Access Compliance Report Public Rights-of-Way (Curb Ramps)

Main Street: **ESPLANADE_ST** Cross Street: **E_CHAPMAN_AVE** Location: **SW**

ADA ID: **RPRK211223133429** Ramp Type: **Type 1 - Perpendicular Diagonal** Initial Pass/Fail: **Fail** Overall Compliance: **No** Severity Score: **0**

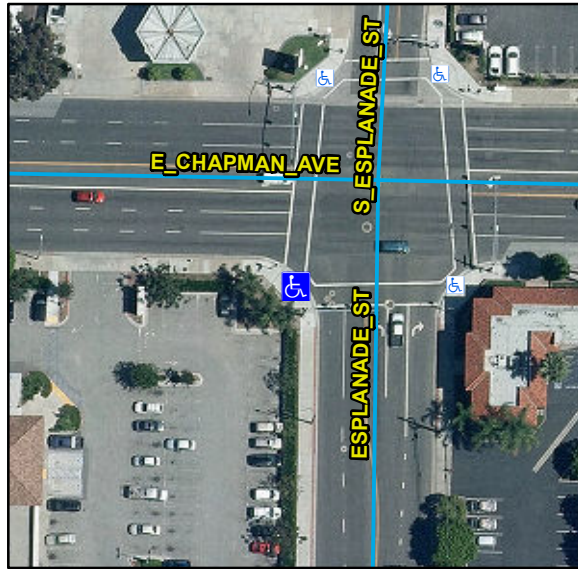
Compliance	Description	Data	Compliance	Description	Data
N/A	Ramp Length (in)	58	N/A	Flare Type LT	
Yes	Ramp Width (in)	48			N/A
Yes	Ramp Run Slope (%)	5.7	N/A	Flare Slope LT (%)	N/A
Yes	Ramp Cross Slope (%)	2.1	N/A	Flare Traversable LT	N/A
N/A	Landing Present	N/A	N/A	Flare Type RT	
N/A	Landing Length (in)	N/A			N/A
N/A	Landing Width (in)	N/A	N/A	Flare Slope RT (%)	N/A
N/A	Landing Run Slope (%)	N/A	N/A	Flare Traversable RT	N/A
N/A	Landing Cross Slope (%)	N/A	N/A	DWS Provided	N/A
N/A	Landing Movement Obstructed?	N/A	N/A	DWS Contrast	N/A
	Landing Movement Type	N/A	N/A	DWS Length (in)	N/A
N/A	Landing Shared	N/A	N/A	DWS Full Width	N/A
N/A	Clear Space	Yes	N/A	DWS Offset Left (in)	N/A
N/A	Clear Space To Crosswalk (in)	48	N/A	DWS Offset Right (in)	N/A
N/A	Marked Crosswalk 1	Yes	N/A	Marked Crosswalk 2	Yes
	Crossing 1 Direction	E		Crossing 2 Direction	N
	Marked Crosswalk 1 Width (in)	144		Marked Crosswalk 2 Width (in)	144

N/A	Ramp Inside Crosswalk 1	Yes	Yes	Ramp Inside Crosswalk 2	Yes
	Crossing 1 Slope (%)	6.6		Crossing 2 Slope (%)	6
	Crossing 1 Cross Slope (%)	1		Crossing 2 Cross Slope (%)	2.3
N/A	Gutter Ponding	N/A	Yes	Curb Slope	2.5
Yes	Gutter Lip Height (in)	0		Road Run Slope (%)	2.9
N/A	Gutter Run Slope (%)	N/A		Road Cross Slope (%)	3.8
N/A	Gutter Cross Slope (%)	N/A			
Yes	Overall Surface Condition: Acceptable		Yes	Perp Joint Present	Yes
	Cross Gutter Present?	No		Spandrel Present?	No
	Replace Cross Gutter?	N/A		Replace Spandrel?	N/A

Remove & Replace Curb Ramp With Two New Directional Ramps or Equivalent.
